Subject: TRIMMED: DA 2023/1395 - Lot 2 DP314645 AND Lot 3 and Lot4 Sec 1

DP677,1010,1012 & 1014 Pittwater Rd Collaroy.

Grounds for our objections.

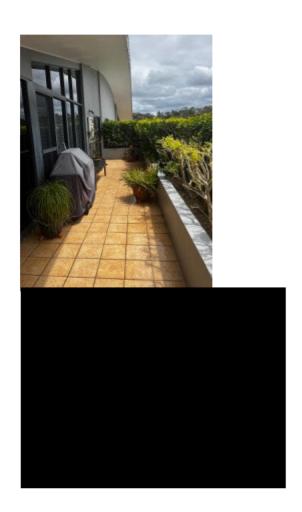
The attached photos reflect the areas of concern that will be directly impacted by the erection of a blind wall flush and adjacent to our building boundry extending 4.5m above the northern facing balcony floor level.

- With no building setback on the Northern Boundary of the Collaroy Reef Apartments, a 4.5m wall is planed to be erected adjacent to our north facing 8m Balcony, resulting in shadowing, lack of airflow and outlook. This balcony is our prime sauce of light and airflow to our only living space and 2 of our 3bedrooms. The erection of this wall adjacent to our balcony will mean that artificial lighting will need to be on at all times to north facing rooms. In view of Climate Change predications not a favourable outcome or for an amiable living environment.
